## ***Interactive comment on “Spatial and temporal dynamics of CO<sub>2</sub> partial pressure in the Yellow River, China” by L. Ran et al.***

**L. Ran et al.**

Received and published: 5 January 2015

**Fig. 1.** DIC species vs. pH graph

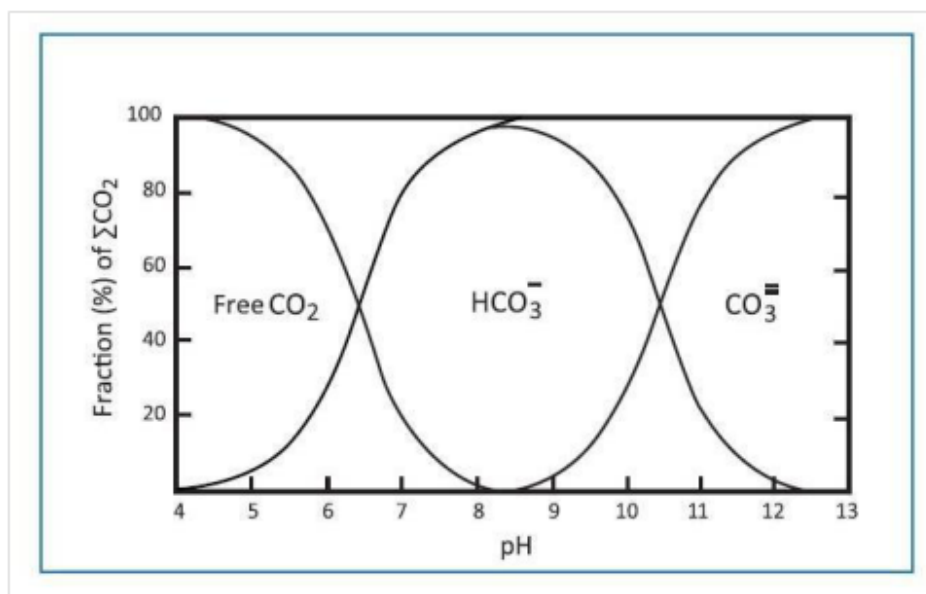
Page 14076: In line 6 you talk about low pCO<sub>2</sub> caused by low TALK and high pH, in line 25 you talk about high pCO<sub>2</sub> resulted by high TALK. You stated that you used HCO<sub>3</sub><sup>-</sup> as proxy for TALK (chapter 2.4). If you consider the classic DIC species vs. pH graph (Fig. 1; source: Wetzel, R.G. 2001. Limnology. Lake and River Ecosystems. Third Ed. Academic Press, San Diego. xvi, 1006 pp. ISBN 0-12-744760-1.): How can you explain your findings? Please discuss this aspect in more detail.

“In the Yellow River, the pH ranges from 7.4 to 8.6, indicating that the DIC species are mainly composed of HCO<sub>3</sub><sup>-</sup> as shown in the figure. Meanwhile, the pH range suggests that CO<sub>3</sub><sup>2-</sup> and free CO<sub>2</sub> account for a very small fraction of the DIC. The headwater region had a 25% lower TALK (or HCO<sub>3</sub><sup>-</sup>) concentration and a 7% higher pH than the basin average, causing a lower pCO<sub>2</sub> based on the Eqs. (1-8). While in the QZ sub-basin, although the pH is lower ranging from 7.4 to 7.7 (Fig. 2a), the DIC species are still mainly composed of HCO<sub>3</sub><sup>-</sup>. As a result of strong rock weathering,

its TALK concentration is the highest, leading to the highest pCO<sub>2</sub> compared with other sub-basins. We have further discussed this in the manuscript. (P8, Line 6-27).”
